## Roads and Assets Referral Response

Application Number:	DA2021/2639

Date:	01/06/2022
То:	Olivia Ramage
• ` ` '	Lot 52 DP 7593 , 25 Alleyne Avenue NORTH NARRABEEN NSW 2101

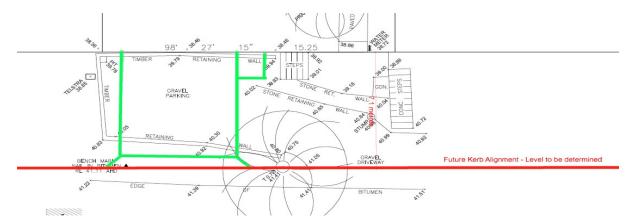
The design plan dated 22/5/2022 also does not comply with low level skew profile levels and the use of such a profile on the current alignment of the unauthorised parking area is not supported. A driveway crossing perpendicular to the carriageway is required in compliance with Council's standards.

The existing road surface levels may be lower than that required in the future. If road levels are raised, to be consistent with the existing longitudinal grade of the road, the driveway (which are at maximum grades) and car port levels will be impacted.

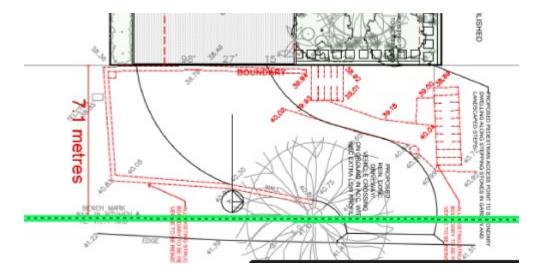
The construction of kerb and gutter across the frontage to connect to the existing k&g would be supported and would aid stormwater drainage.

Driveway access from the carriageway should be at 90 degrees to the carriageway to improve safe access, although noting this may result in lifting the car port floor level.

Once an agreed concept is provided and supported, Council's Development Engineering Team to require Application for Civil Works (Road Act 1993) for detailed engineering design plans to address driveway construction (including alignment and level of proposed driveway layback to ensure consistency with the existing kerb and gutter alignment and levels) associated structures (walls or earthworks) structural support of the driveway and public road reserve. The alignment of the driveway layback for future provision of k&g construction is likely to impact driveway levels.
